INSTALLATION OF CUSHION BARRIER
AT LUNALILO FRWY - VINEYARD (OFF-RAMP)
& STA. 83+00
SAFETY IMPROVEMENTS ALONG
INTERSTATE H-1
KALIHI ST. TO PALI HIGHWAY
Proj. No. I-HI-1(112):19 Date: April, 1973

STATE OF HAWAII
DEPARTMENT OF TRANSPORTATION
HIGHWAYS DIVISION
INSTALLATION OF CUSHION BARRIER
AT LUNALILO FRWY. & RAMP "5"
@ Sta. 103+50
SAFETY IMPROVEMENTS ALONG
INTERSTATE H-1
KALIHI ST. TO PALI HIGHWAY
Proj. No. I-H-1(112)19 DATE: April, 1973

C. O. 45

SAFETY IMPROVEMENTS ALONG
INTERSTATE H-1
KALIHI ST. TO PALI HIGHWAY

Ref. Front face of Conc. Barrier. See "Plan" on sht. #5C for alignment.

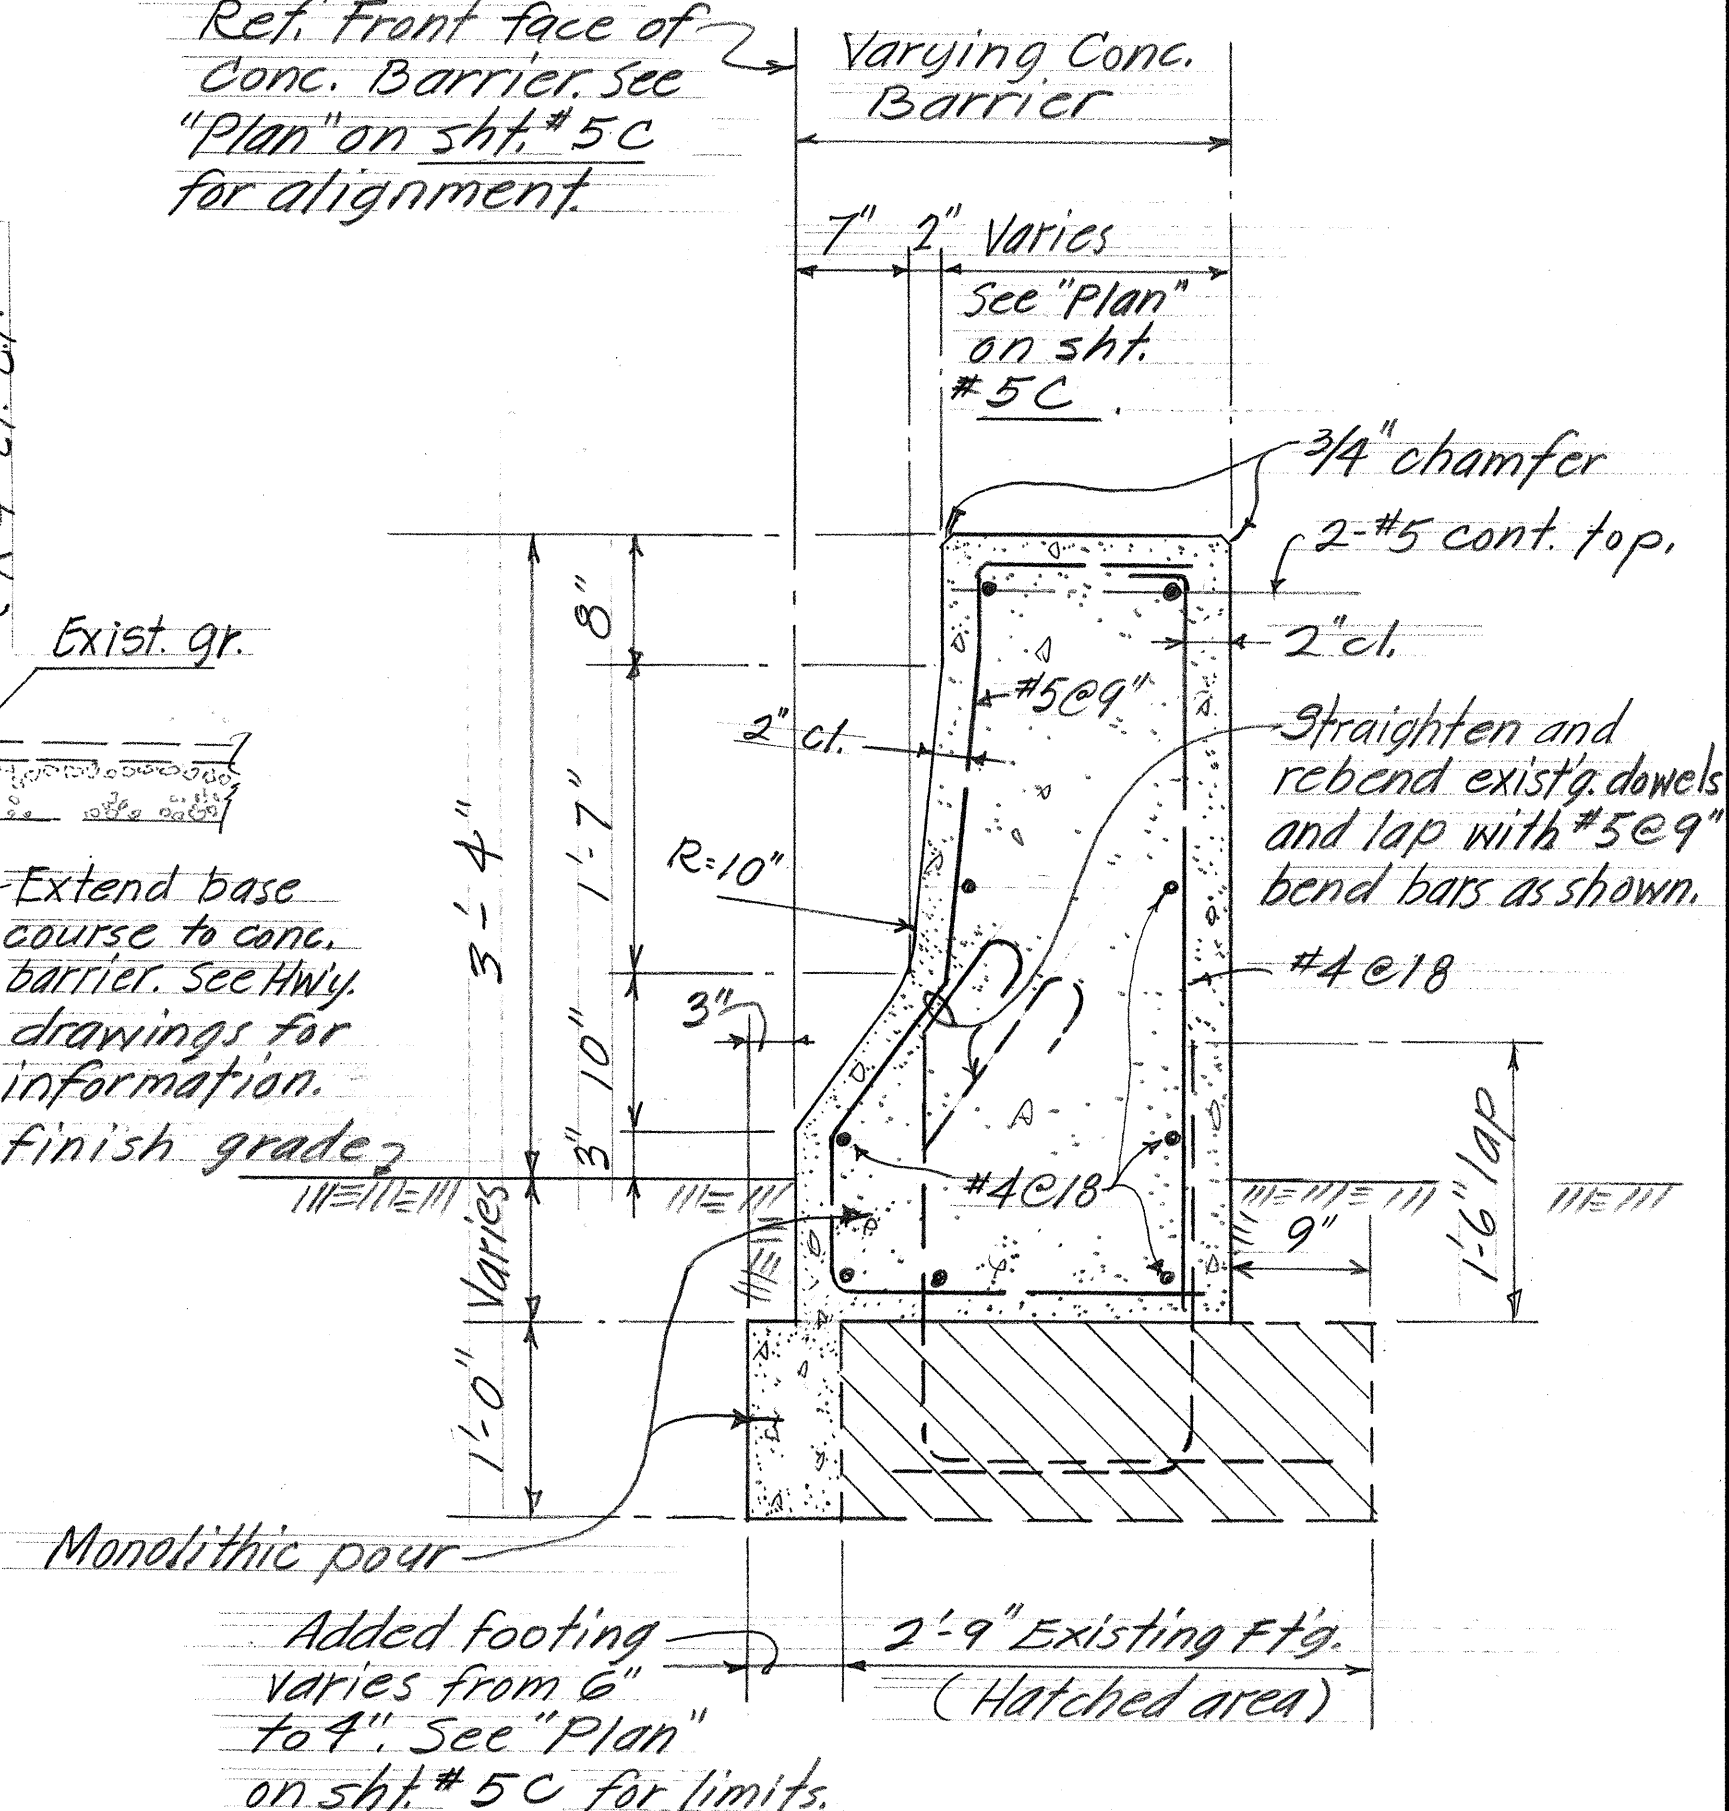
11-27-'74 Buttness width increased from 6' to 7'-0" due to modification of cushion barrier system. Adjoining concrete barrier revised to match revised buttness.
